**TOWN OF NEWBURGH
PLANNING BOARD
TECHNICAL REVIEW COMMENTS**

PROJECT: 233 QUAKER ST/DRIVANOS 2 FAMILY
PROJECT NO.: 18-19
PROJECT LOCATION: SECTION 2, BLOCK 1, LOT 15
REVIEW DATE: 29 NOVEMBER 2018
MEETING DATE: 6 DECEMBER 2018
PROJECT REPRESENTATIVE: MICHAEL AIELLO, P.E./LINDA ZWART, R.A.

FLOOR PLANS & ELEVATIONS

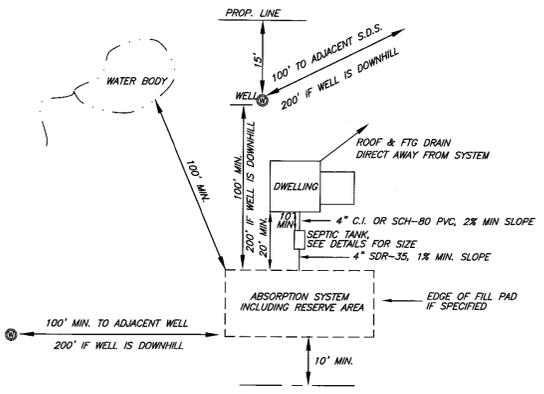
1. Architectural details of the building façade have been provided. Two separate entrances are identified on the architectural details for each of the proposed units. Each of these entrances are on a different side of the structure. The Planning Board should review the project with regard to Section 185-48.2B, “the architecture and entrance details of the units shall provide the appearance of a single family residence.” As the entrances are located on separate sides the Board may consider the two separate entrances to comply with this requirement.
2. Submission of County to County planning as the project is located on the county line is required.
3. A Public Hearing for the two family dwelling is required.
